**SEWARD ORIGINAL TOWNSITE  
VERHEY REPLAT**

**KPB 2023-108**

**ITEM #4 - PRELIMINARY PLAT  
SEWARD ORIGINAL TOWNSITE VERHEY REPLAT**

<b>KPB File No.</b>	2023-108
<b>Plat Committee Meeting:</b>	November 13, 2023
<b>Applicant / Owner:</b>	Vanessa, Richard, and Janette Verhey all of Seward, Alaska
<b>Surveyor:</b>	Stacy Wessel / AK Land Surveying
<b>General Location:</b>	City of Seward

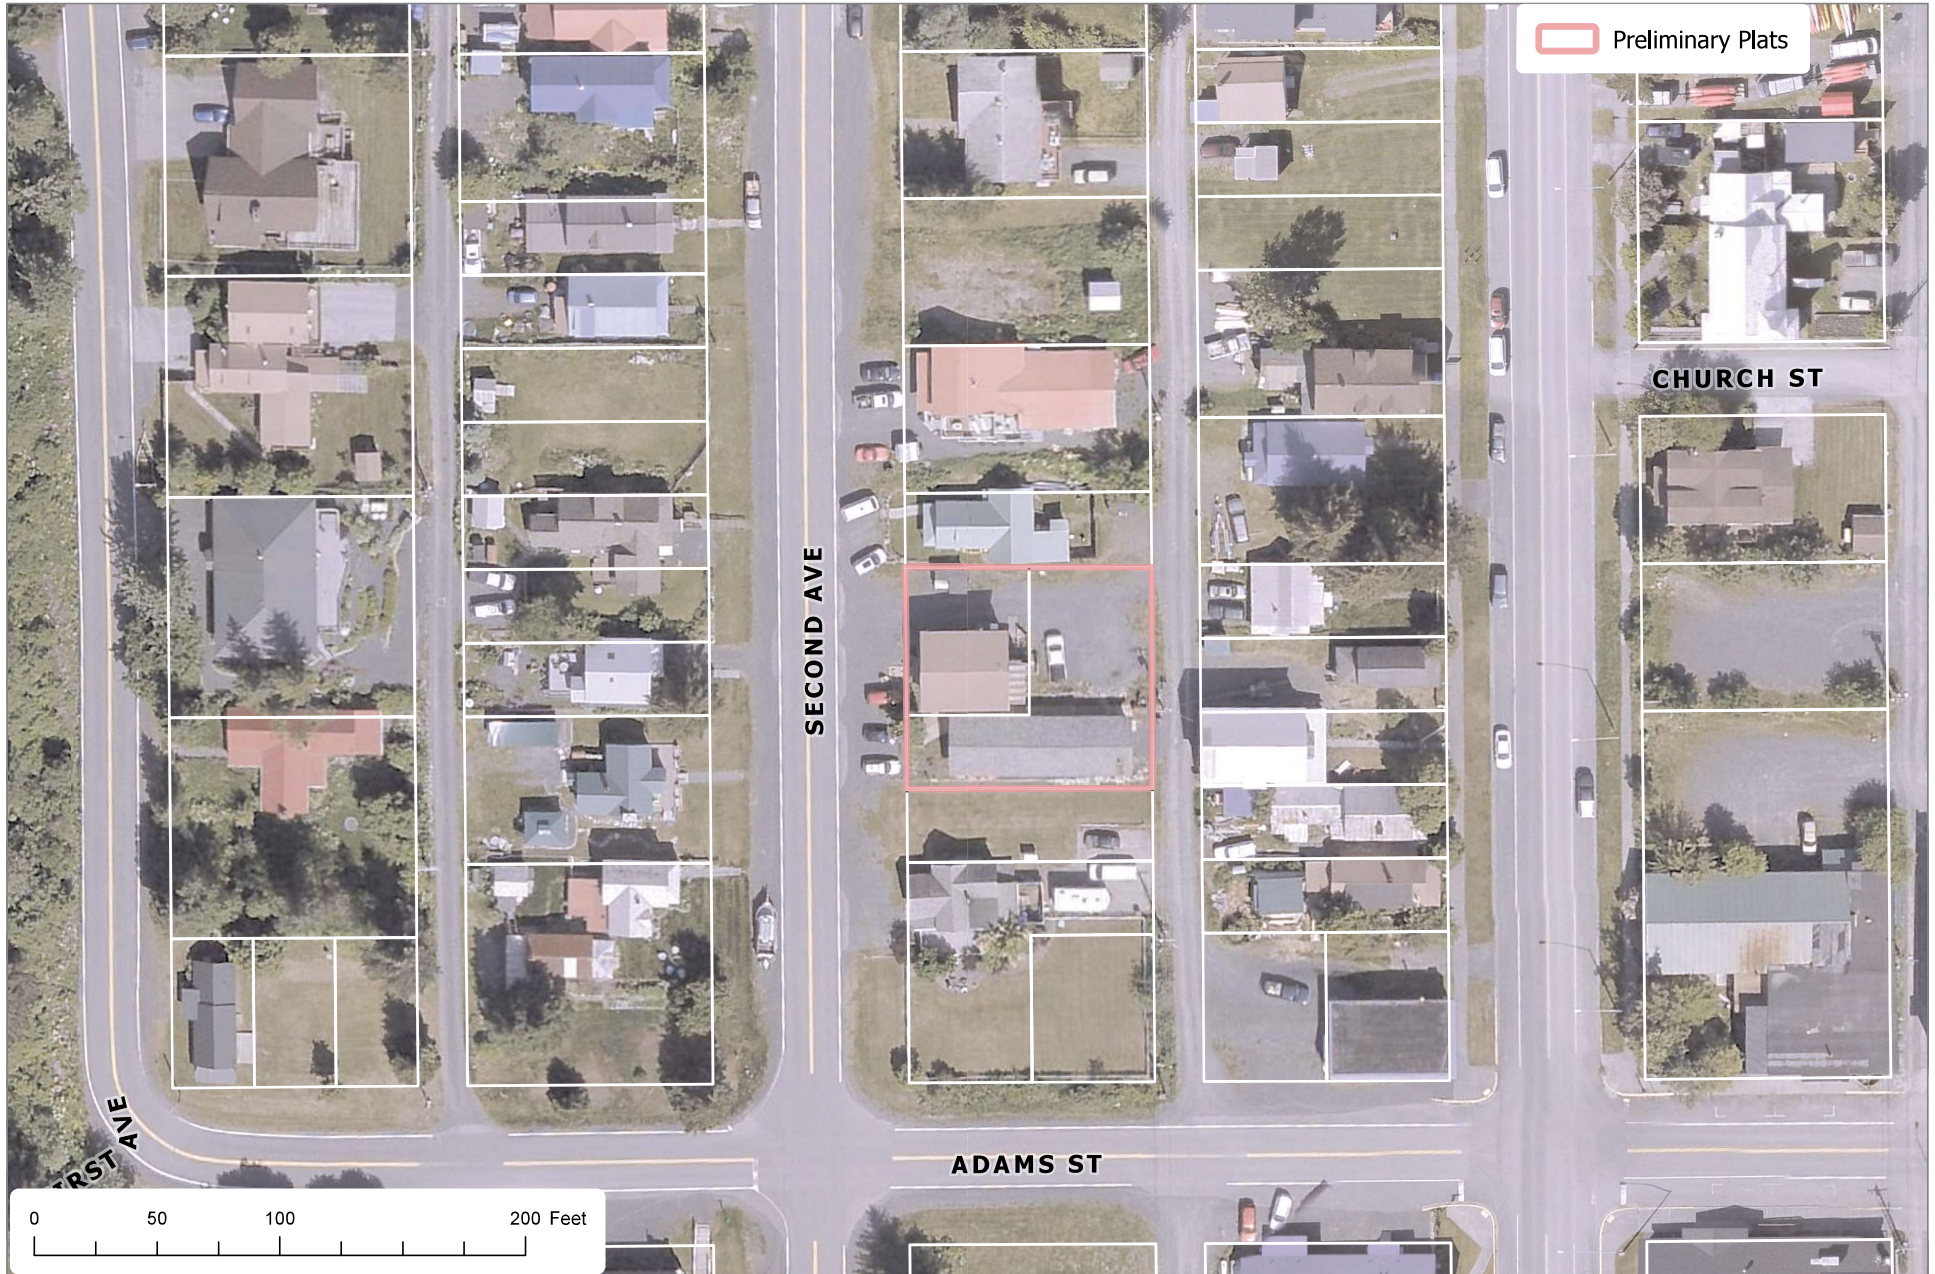
**Utility Easements** The only utility easement within the boundary of the subdivision is the 15-foot utility and sewer easement. **Staff recommends:** *providing a callout or something similar, so that it is clear what the label is referencing.*

Scale of plat should be at a scale of 1" =20' to be in compliance with 20.60.070.

**Staff recommendation:** Please verify the address for Richard and Jannette Verhey. The tax roll indicates a different address. If the address is correct, we recommend the owners contact the Assessing Department to have their address updated. Richard and Janette are in title with their middle initials. Please add this in the signature and title blocks.

Add ALASKA under KENAI PENINSULA BOROUGH in the legal.

**Staff recommendation:** The city limits end on the west boundary of sections four and nine. Please provide a label.
- G. The status of adjacent lands within 100 feet of the proposed subdivision boundary or the land status across from any dedicated rights-of-way that adjoin the propose subdivision boundary, including names of subdivisions, lot lines, block numbers, lot numbers, rights-of-way; or an indication that the adjacent land is not subdivided;

**Staff recommendation:** Lot labels are present on the plat, please add block labels and recording identifier to each label.
- J. Block and lot numbering per KPB 20.60.140, approximate dimensions and total numbers of proposed lots;

**Staff recommendation:** Pervious names of lots can be removed on the final..

**Staff recommendation:** Any area of the subdivision within the floodplain, floodway or Seward Mapped Flood Data Area (SMFDA) is to be shown and labeled on the plat.

*Platting Staff Comments:* Please provide proper wastewater disposal notes.

- Certificate of Ownership and Dedication both need to be specific to each owner
- Third Certificate of Ownership needs the statement paragraph added
- Notary Acknowledgement needs adjusted to appropriate signature lines.
- Add meeting date of November 13<sup>th</sup>, 2023 to Plat Approval.

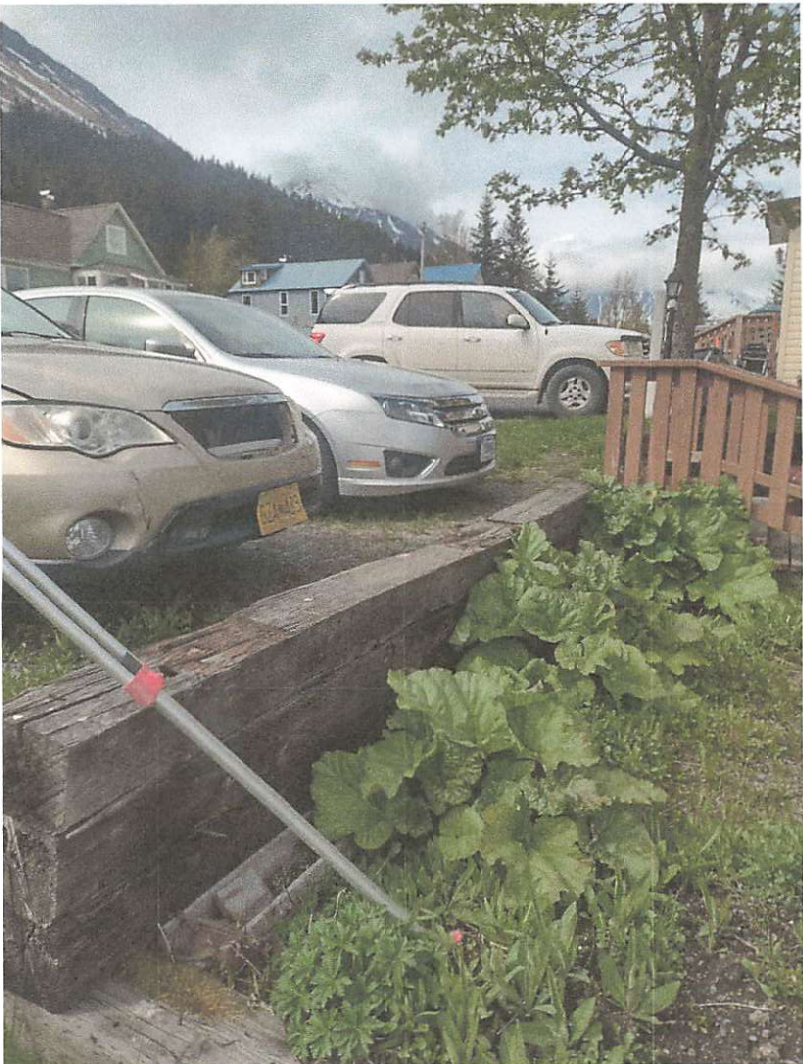
- a. A boardwalk wraps around the northerly part of the building. The boardwalk extends a little bit more than ½ foot into the W1/2 of Lot 26. The boardwalk is similar to the one described above, its a couple inches above grade, and does not appear to be a permanent structure fixed to the ground.

- b. There is a short, wooden retaining wall that extends from the SW corner of 310 2<sup>nd</sup> Ave, jags towards the westerly property line of Lot 25 A, Block 14, runs parallel along said property line, then protrudes west extending into 2<sup>nd</sup> Ave. The wooden retaining wall serves to support the parking area in front of both buildings and protects the change of grade between the parking area and buildings. The wooden retaining wall does not impede nor obstruct traffic.

(REVISION 2) AS-BUILT OF  
LOT 25A, BLOCK 14, SEWARD ORIGINAL TOWNSITE,  
PLAT NO. 2003-16  
THE WEST 1/2 OF LOT 27, BLOCK 14, ORIGINAL  
TOWNSITE OF SEWARD, PLAT NO. 1  
THE WEST 1/2 OF LOT 26, BLOCK 14, ORIGINAL  
TOWNSITE OF SEWARD, PLAT NO. 1

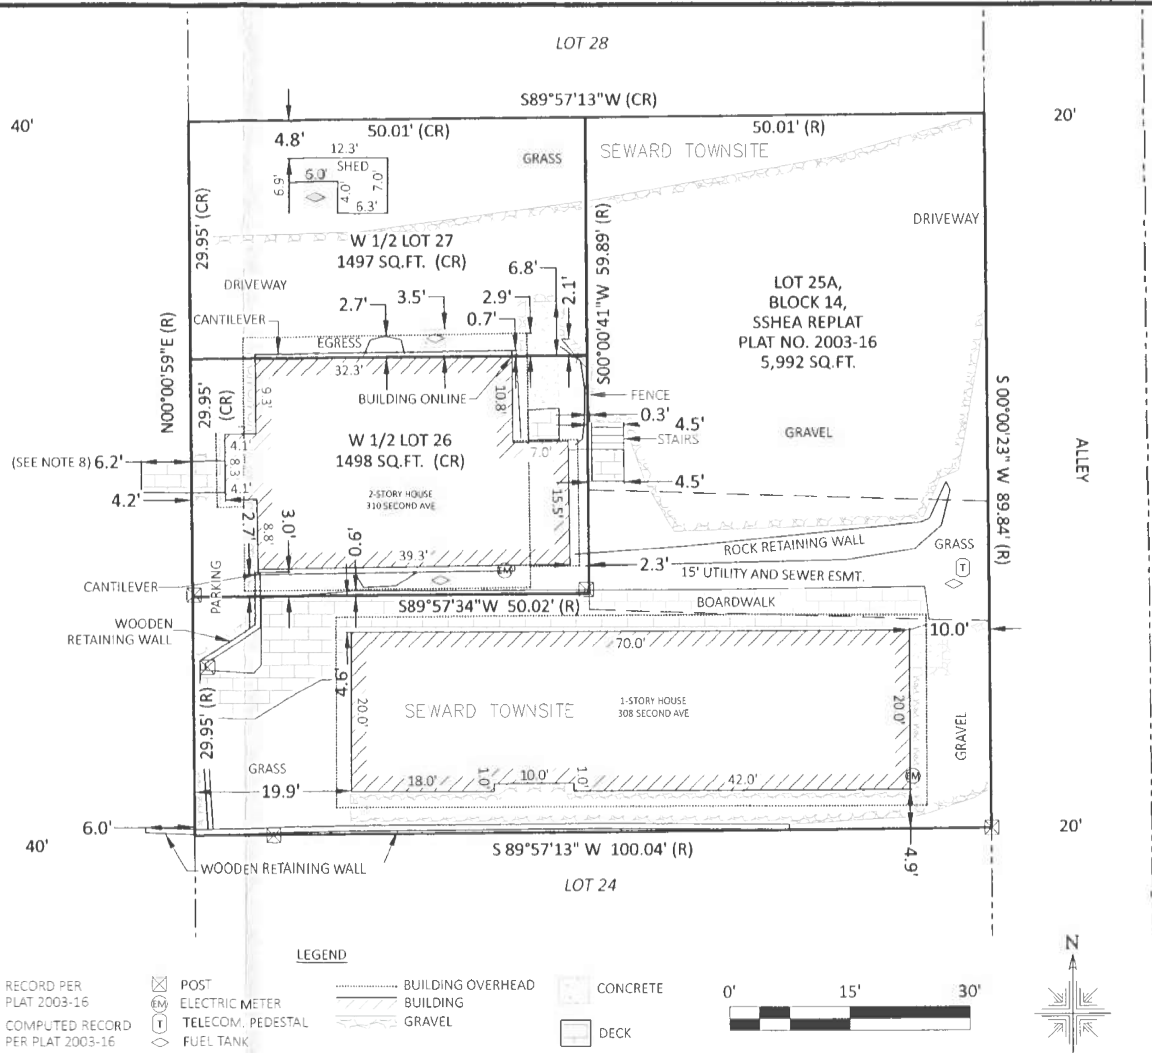
- 4) ENCROACHMENTS INTO THE WEST 1/2 OF LOT 27, BLOCK 14, ORIGINAL TOWNSITE OF SEWARD, PLAT 1.
  - A. THE RETAINING WALL FOR EGRESS ENCROACHES 2.7'.
  - B. THE CONCRETE PAD ENCROACHES 3.5'.

- C. THE CANTILEVER ENCROACHES 0.7'.
  - D. THE ROOF OVERHANG ENCROACHES 2.9'.
  - E. THE CONCRETE PAD ENCROACHES 6.8'.
  - F. THE FENCE ENCROACHES 2.1'.

- 5) ENCROACHMENTS INTO THE WEST 1/2 OF LOT 26, BLOCK 14, ORIGINAL TOWNSITE OF SEWARD, PLAT 1.
  - A. THE BOARDWALK ENCROACHES 0.6'. THE BOARDWALK APPRES A COUPLE INCHES ABOVE GROUND AND DOES NOT APPEAR TO BE A PERMANENT STRUCTURE FIXED TO T

- B. THE RETAINING WALL ENCROACHES 3.0'.
- 6) ENCROACHMENTS ONTO LOT 25A, BLOCK 14, ORIGINAL TOWNSITE OF SEWARD, SHEA REPLAT.
  - A. THE FENCE ENCROACHES 0.3'.

- B. THE STAIRS ENCROACHES 4.5'.
  - C. THE DECK ENCROACHES 4.5'.
- 7) ENCROACHMENTS INTO SECOND AVENUE RIGHT-OF-WAY.
  - A. THE RETAINING WALL ENCROACH 6.0'.

- 8) THE BOARDWALK/DECK EXTENDS 6.2' INTO 2ND AVE. IT LIES A COUPLE OF INCHES ABOVE GRADE AND DOES NOT APPEAR TO BE A PERMANENT STRUCTURE. THIS MAY OR MAY NOT BE AN ENCROACHMENT.
